NAVIGATION - STALL WARNING HORN REPLACEMENT

MODEL	SERIAL NUMBERS
335	335-0001 thru 335-0065
340	340-0001 thru 340-0555
340A	340A0001 thru 340A1817

MEB-34-06
Page 1 of 25

Figure 6. 335/340A Configuration 2 (Sheet 1)

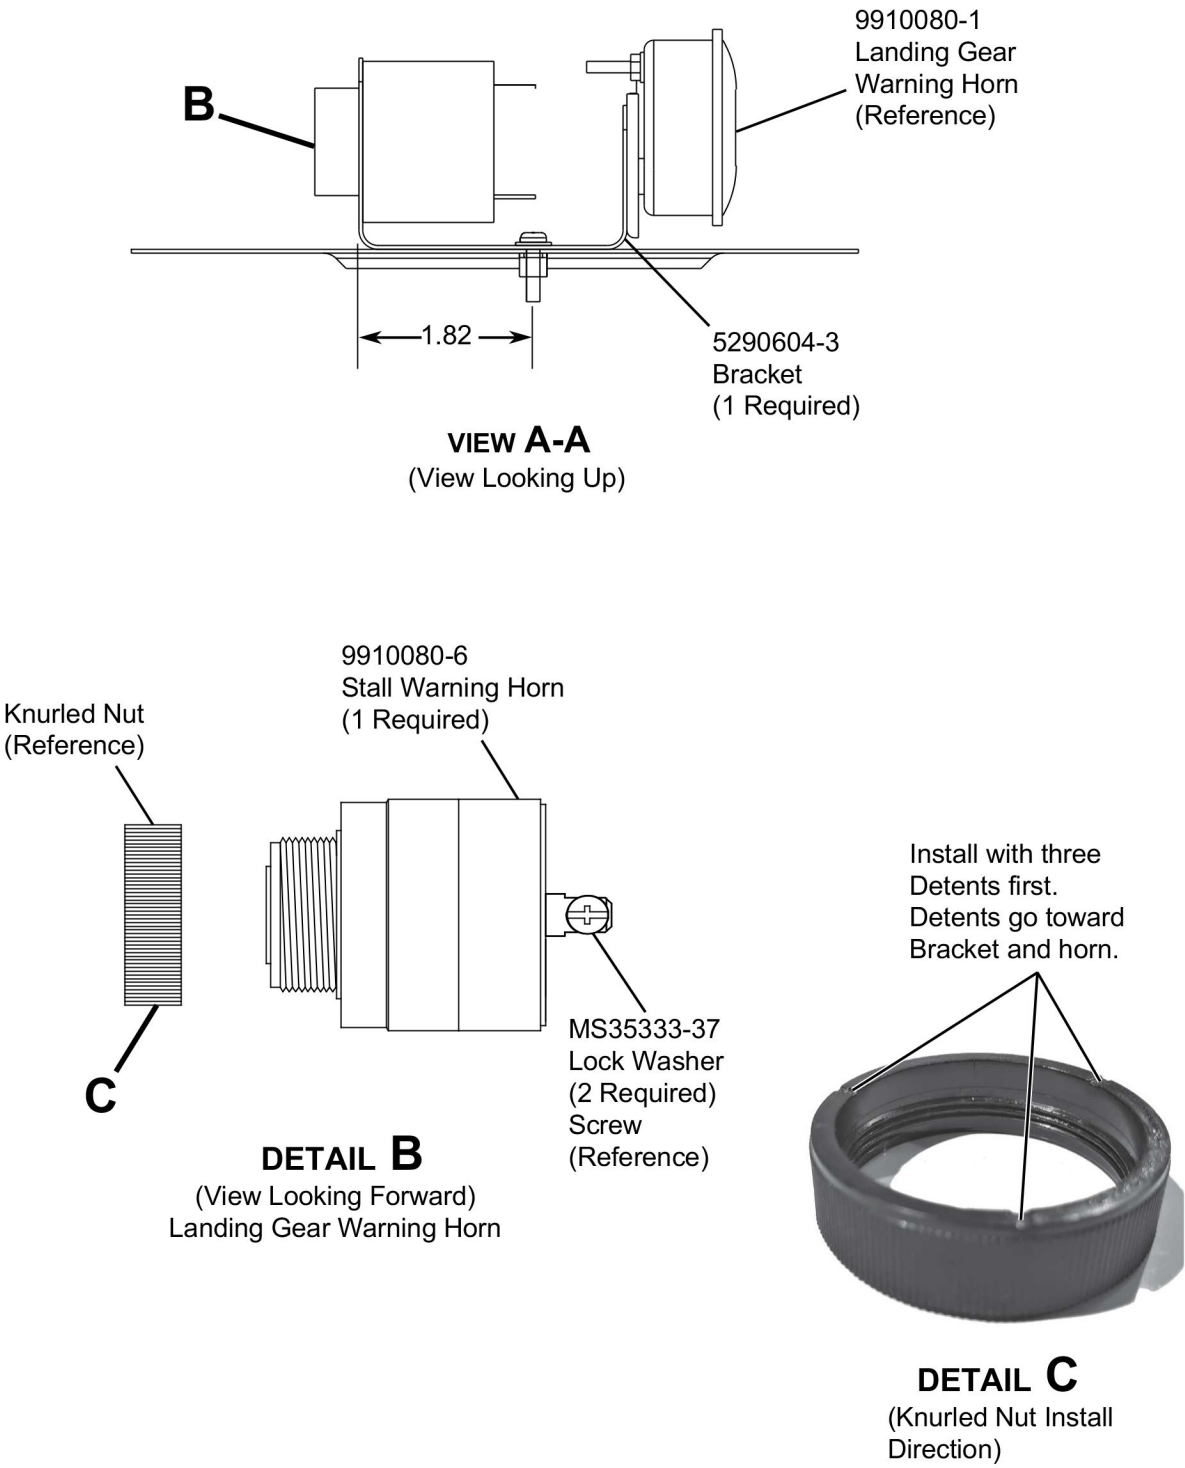
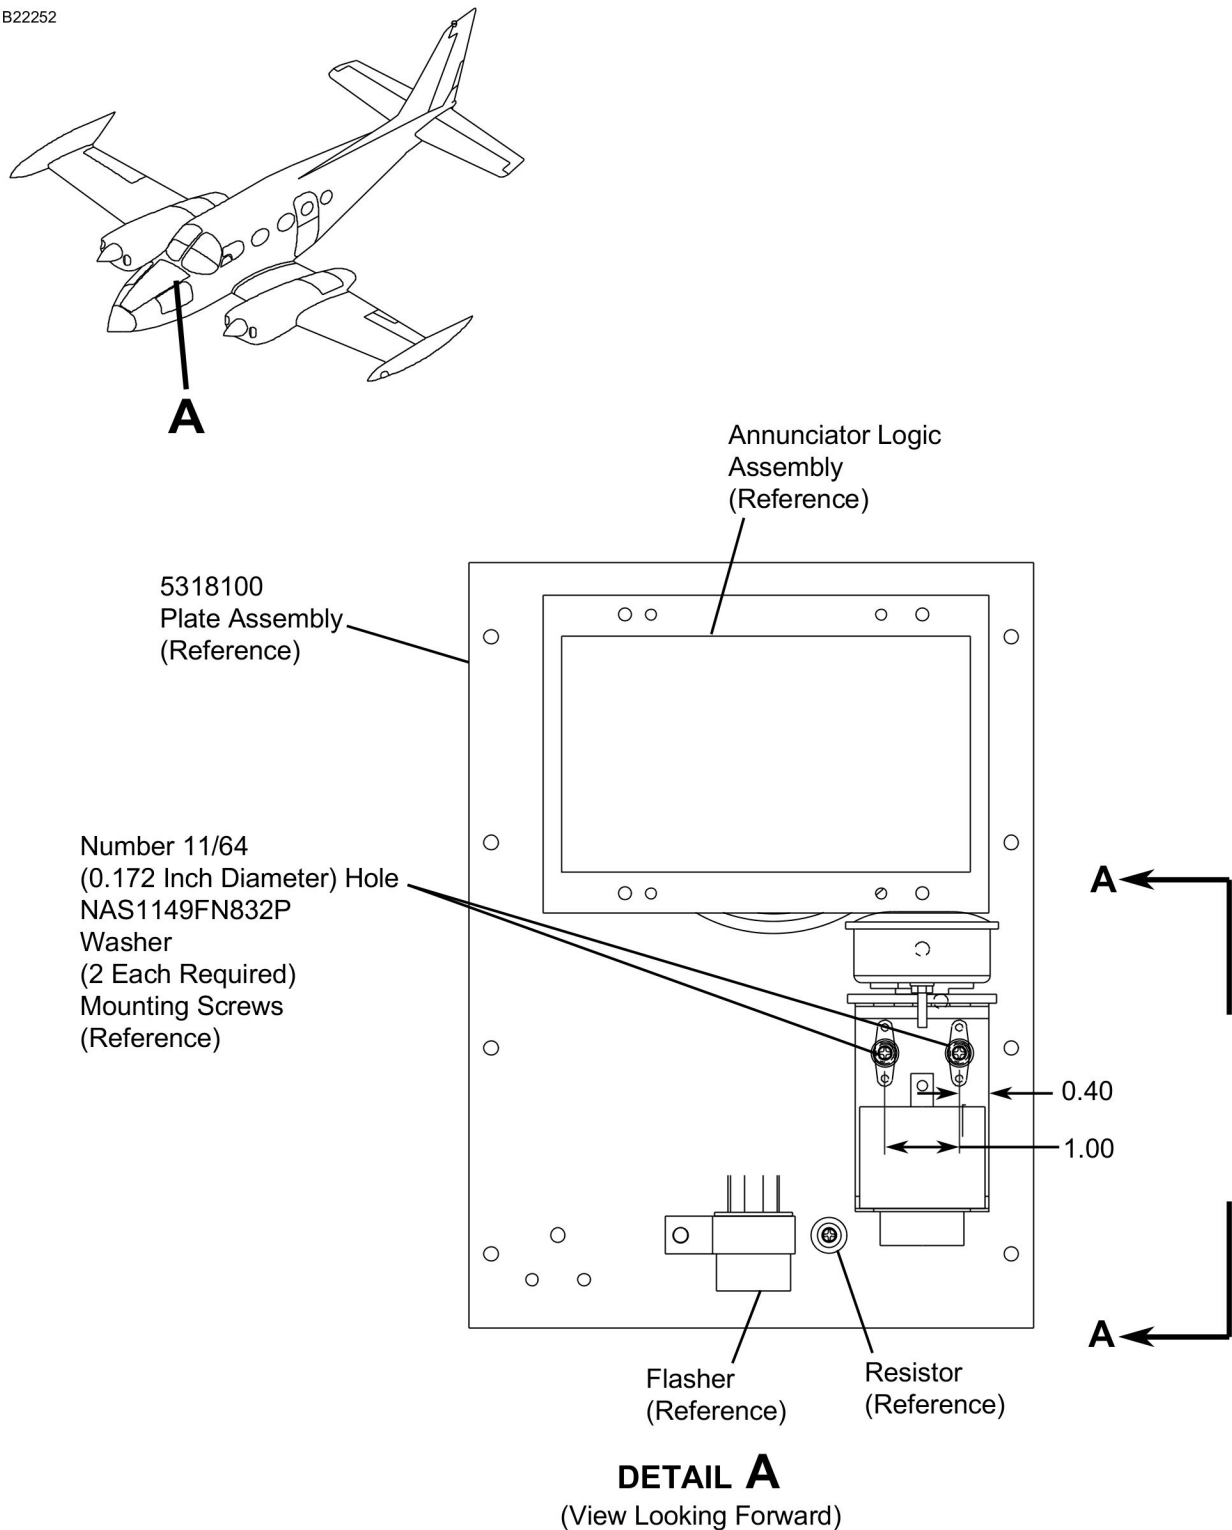
NOTE: The kept mounting screws will be used during installation.
 - H. Discard the 5118331-X Channel.
8. (For Model 340 Refer to Figure 5, Sheet 1 and 2, and for Model 335/340A Figure 6, Sheet 1 and 2.) Install the 9910080-6 Stall Warning Horn as follows:

- (4) Go to Step 8C.
 - B. (For Model 335/340A airplanes.) Match drill the two Number 11/64 (0.172 inch diameter) holes of the 5318100 Plate Assembly to the 5290604-3 Bracket.

- (1) Debur the drilled holes from the 5290604-3 Bracket.
 - (2) Apply Color Chemical Film Treatment to all bare metal.
 - (3) Install the 5290604-3 Bracket with the two kept mounting screws and the two NAS1149FN832P Washers into the 5318100 Plate Assembly.

- C. Install the 9910080-6 Stall Warning Horn into the 5290604-3 Bracket.

Figure 7. 335 Before Configuration 3 Modification (Sheet 1)

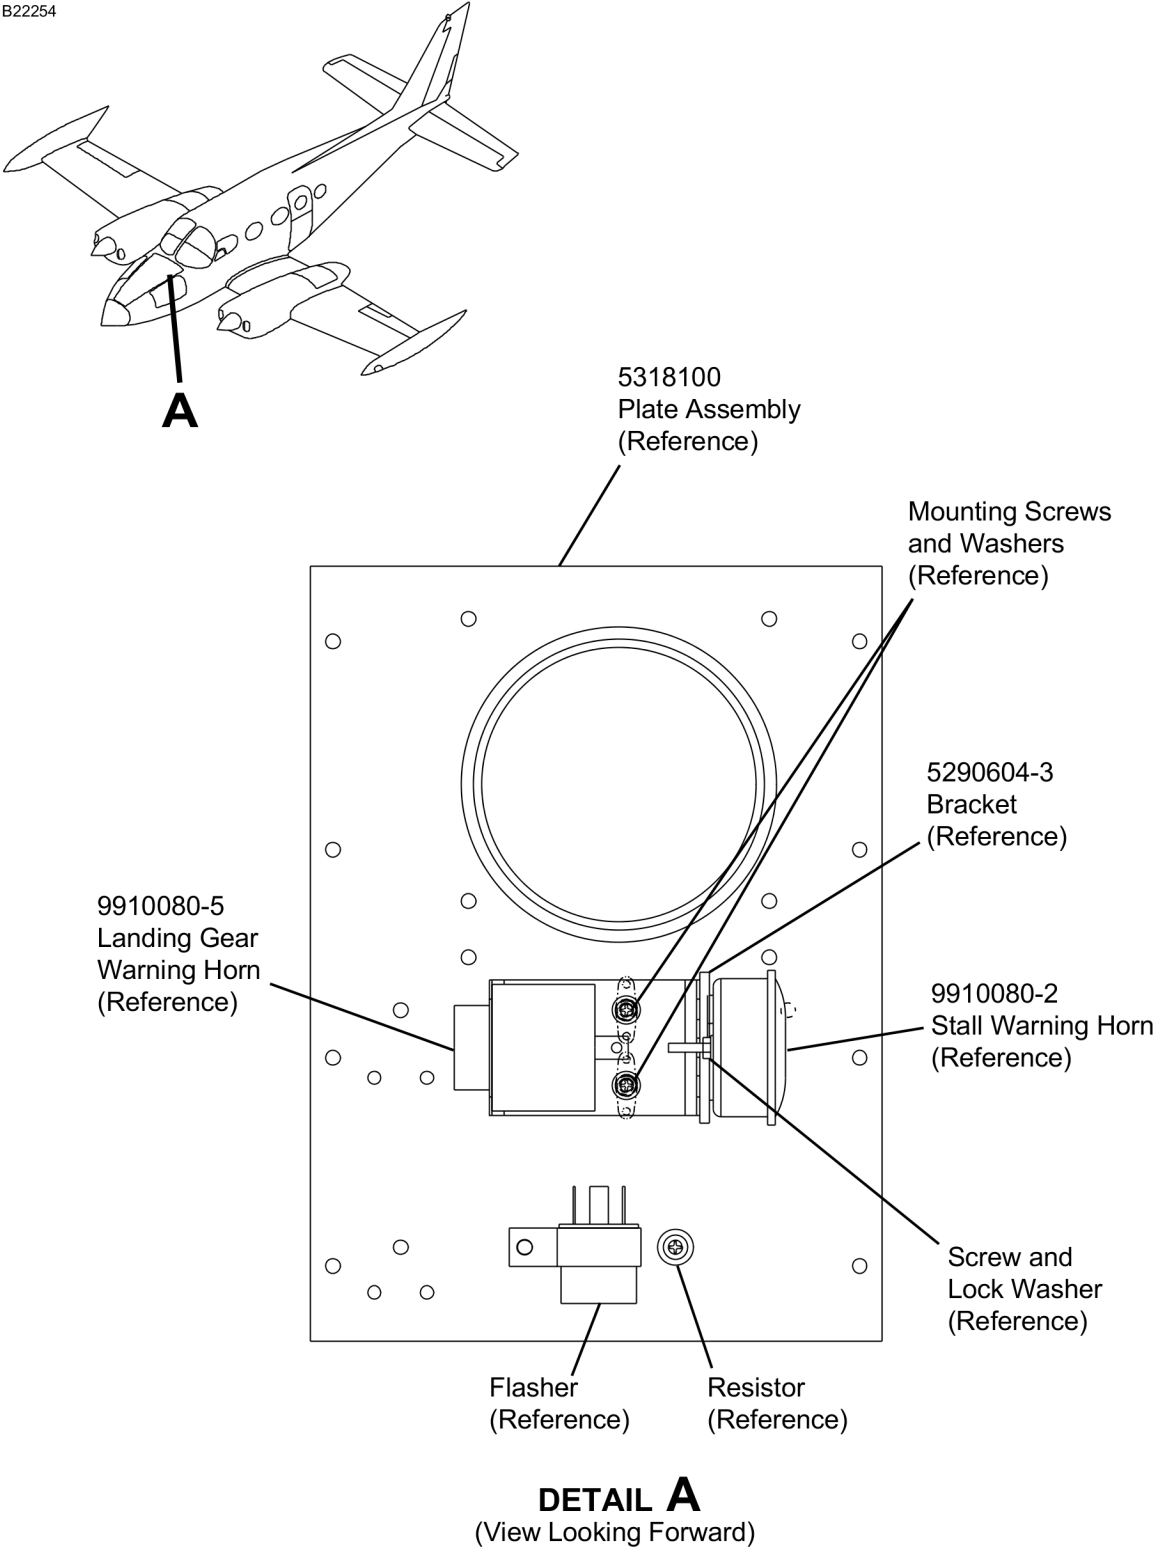
13. (For Model 340 Refer to Figure 7, Sheet 1, and for Model 335/340A Figure 9, Sheet 1.) Remove the 9910080-2 Stall Warning Horn as follows:

- A. Remove and discard the washer and lock screw from the 9910080-2 Stall Warning Horn.
- B. Disconnect and label the electrical wiring from the 9910080-2 Stall Warning Horn.
- C. Discard all electrical hardware from the 9910080-2 Stall Warning Horn.
- D. Discard the 9910080-2 Stall Warning Horn.
- E. Remove and keep the 9910080-5 Landing Gear Warning Horn.

Figure 8. 335 Configuration 3 (Sheet 1)

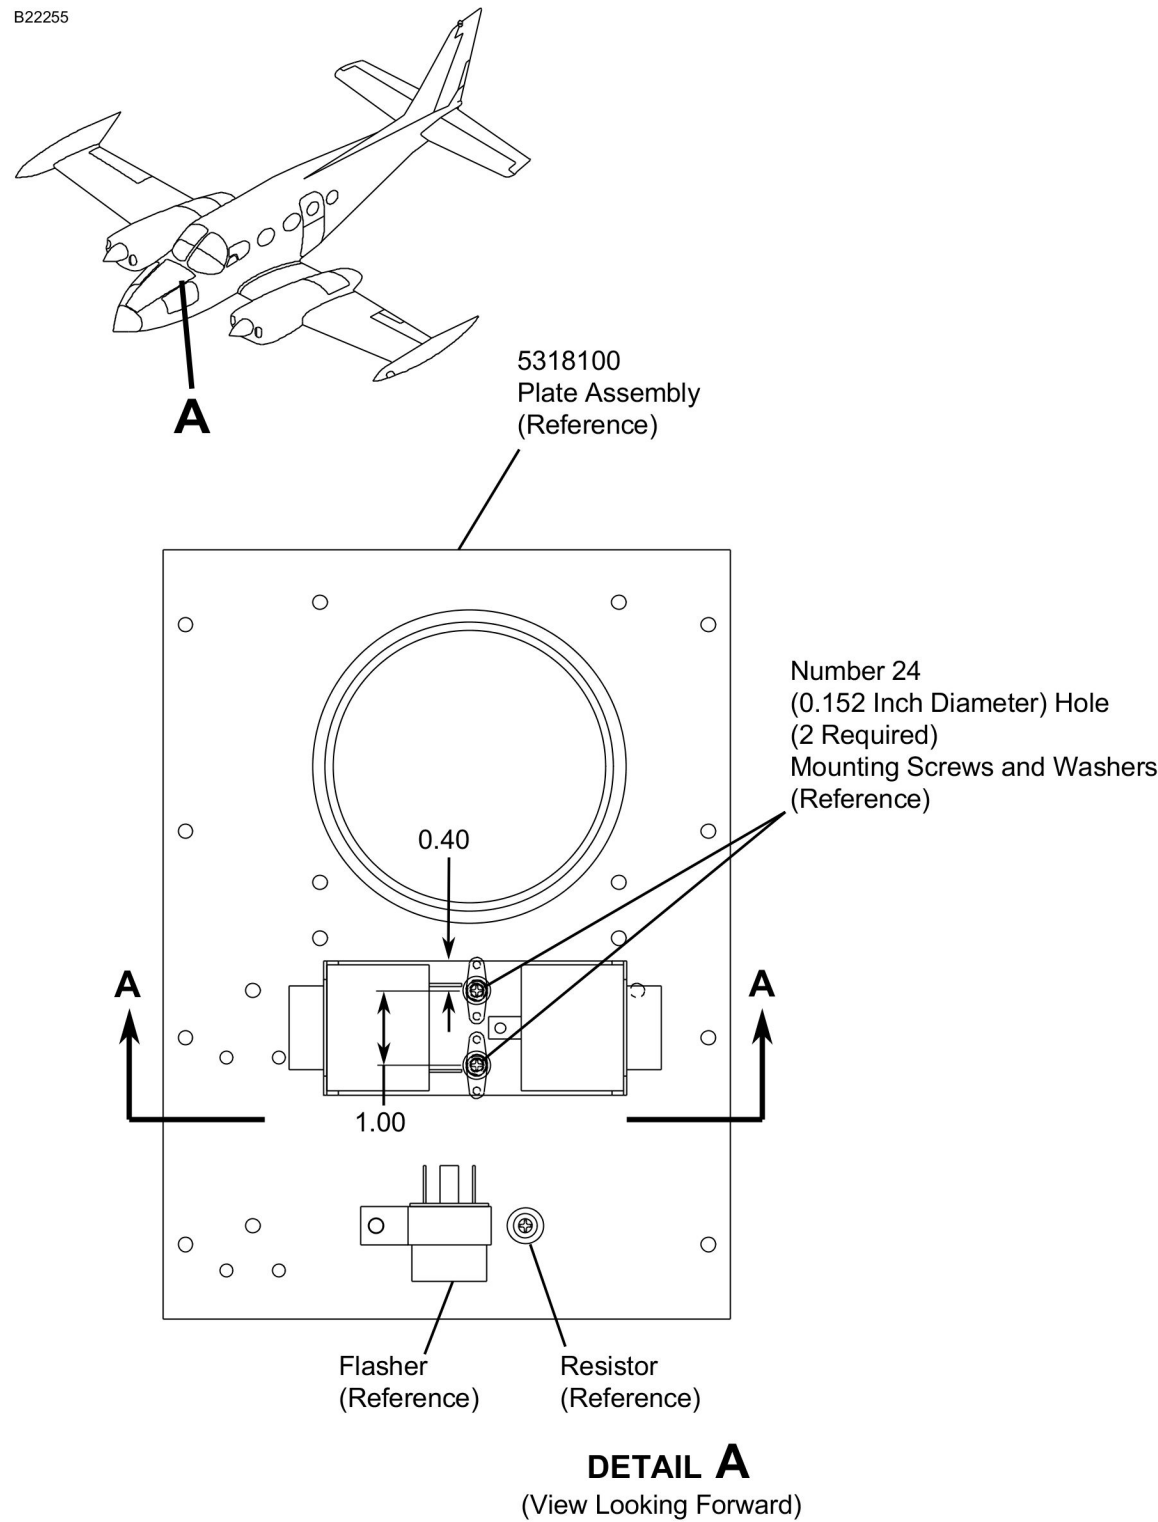
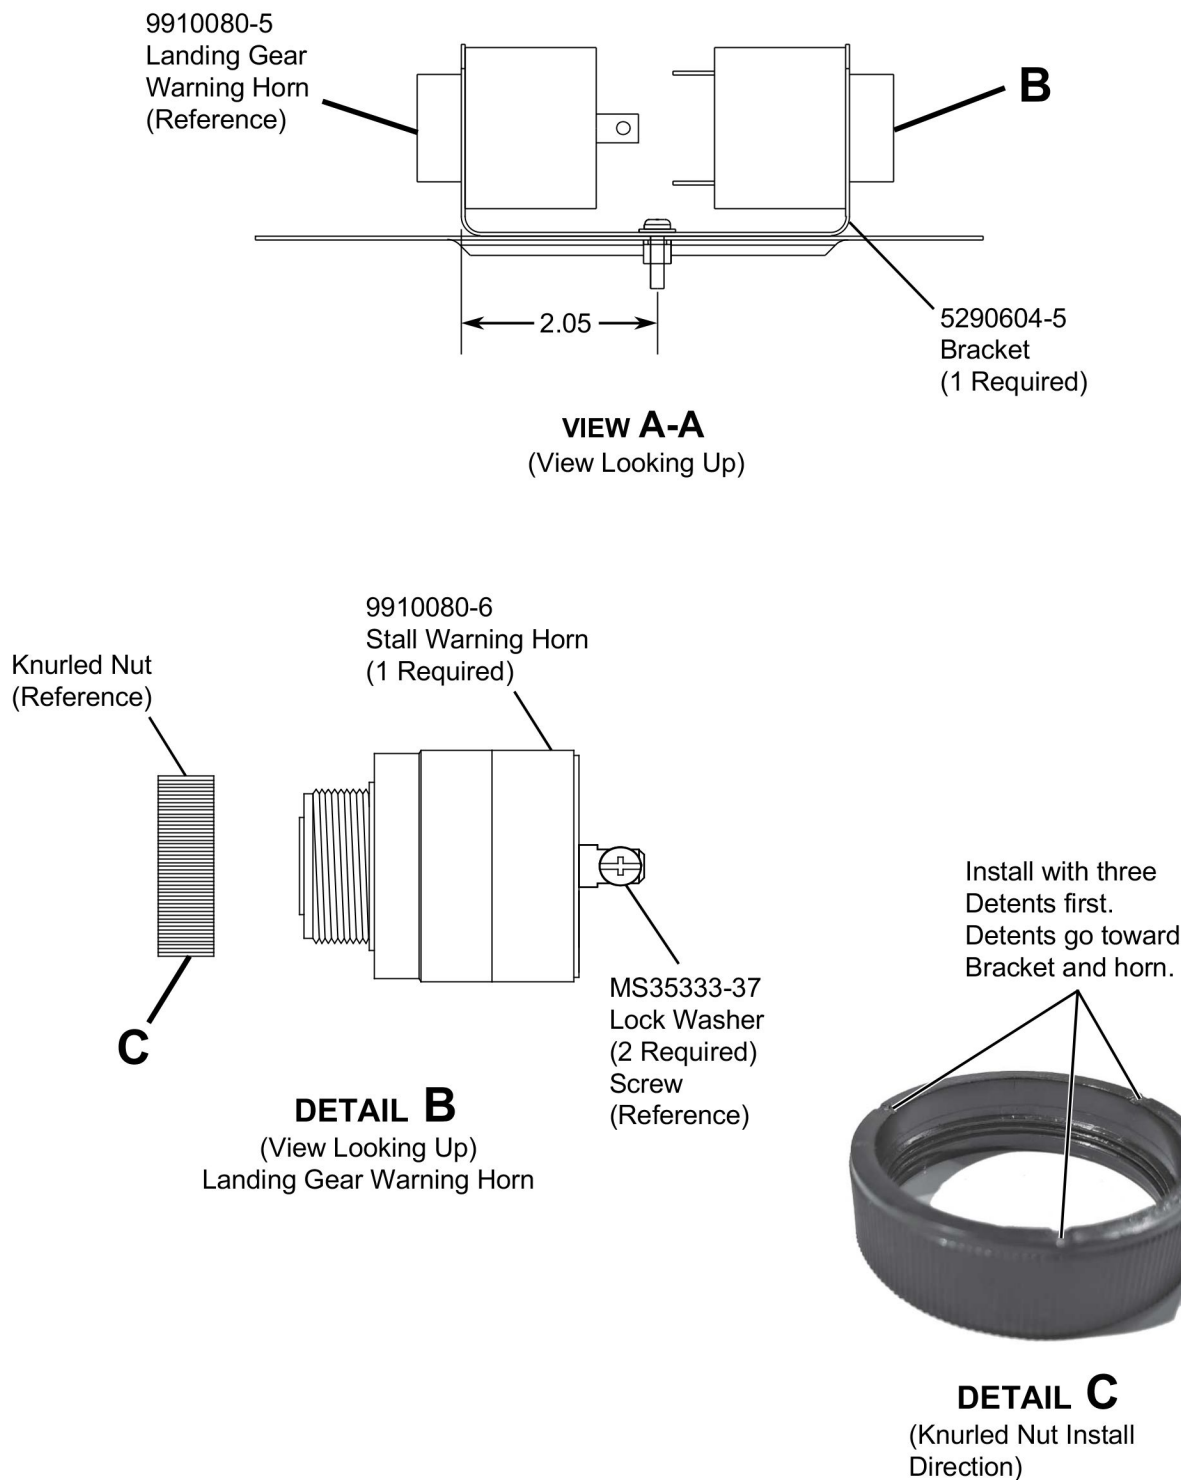
- G. Discard the 5290604-3 Bracket.
14. (For Model 340 Refer to Figure 8, Sheet 1 and 2, and for Model 335/340A Figure 10, Sheet 1 and 2.) Install the 9910080-6 Stall Warning Horn as follows:

- A. (For Model 340 airplanes.) Match drill the two Number 24 (0.152 inch diameter) holes of the 5318100 Plate Assembly to the 5290604-5 Bracket.
- (1) Debur the drilled holes from the 5290604-5 Bracket.

- (2) Apply Color Chemical Film Treatment to all bare metal.
 - (3) Install the 5290604-5 Bracket with the two kept mounting screws and the two kept washers into the 5318100 Plate Assembly.

- C. Install the 9910080-6 Stall Warning Horn into the 5290604-5 Bracket.
- D. Install the knurled nut onto the 9910080-6 Stall Warning Horn.
- NOTE:** The plastic knurled nut must be installed with the three indents toward the bracket and horn assembly. On the internal circumference, the smooth side without threads is installed first, towards the bracket and horn. This technique of installation will make sure the nut fully seats against the bracket and not bottom-out on the threads. If not installed correctly the knurled nut will bottom-out on the threads and the horn assembly will not be fully tightened in the bracket.
